SAN FRANCISCO PLANNING DEPARTMENT

Discretionary Review Abbreviated Analysis

Date: November 15, 2017
Case No.: **2015-018225DRP**
Project Address: **171 JUDSON AVENUE**
Permit Application: 2015.11.09.2182
Zoning: RH-1 [Residential House, Single Family]
40-X Height and Bulk District
Block/Lot: 3182/032
Project Sponsor: Suheil Shatara
26 Lakeview Drive
Daly City, CA 94015
Staff Contact: Sylvia Jimenez – (415) 575-9187
Sylvia.Jimenez@sfgov.org
Recommendation: **Do not take DR and approve as proposed**

Vertical Expansion

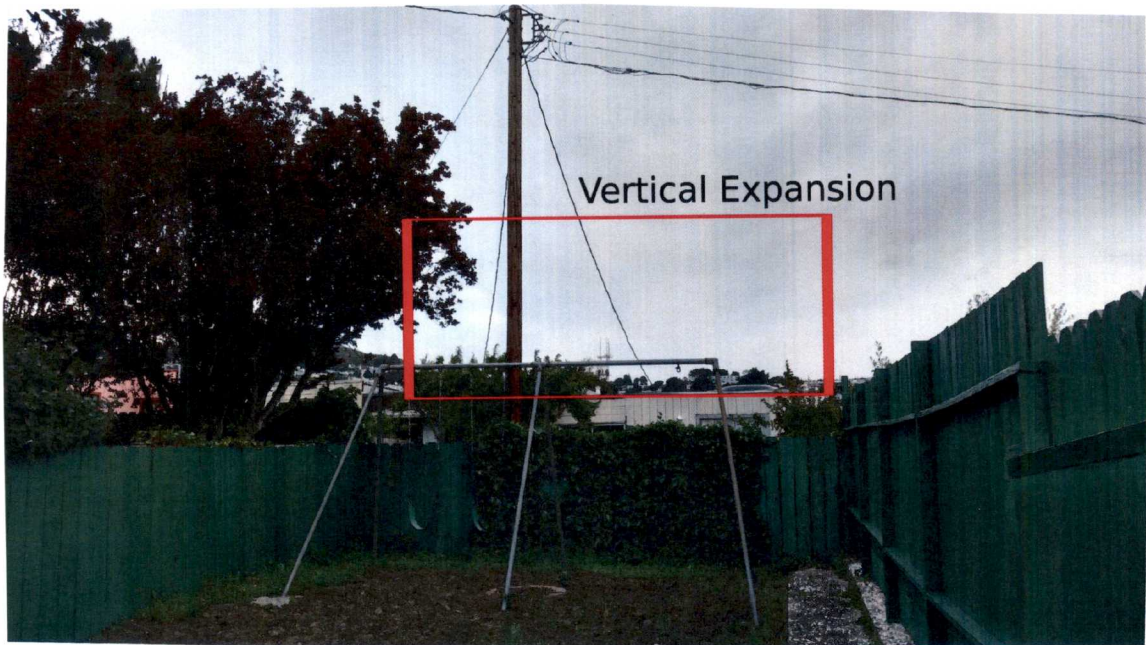
We believe the proposed vertical addition with rear deck and total of 7 bedrooms will drastically change the character of our neighborhood. Our block, in particular, has a visual character that is uniform in scale with no homes having a third story addition or rear deck, that I am aware of. The proposed plans will disrupt the existing pattern and be an eye sore, especially with the rear deck that will sit high above the fence line and be visible from nearly every backyard in the block where none currently exist.

The project complies with the planning code, neighbors have concern for the privacy even though we are more than 100' away from the neighbors and additional set back the all 3 sides to provide additional privacy to adjacent neighbors and neighbors behind the subject .
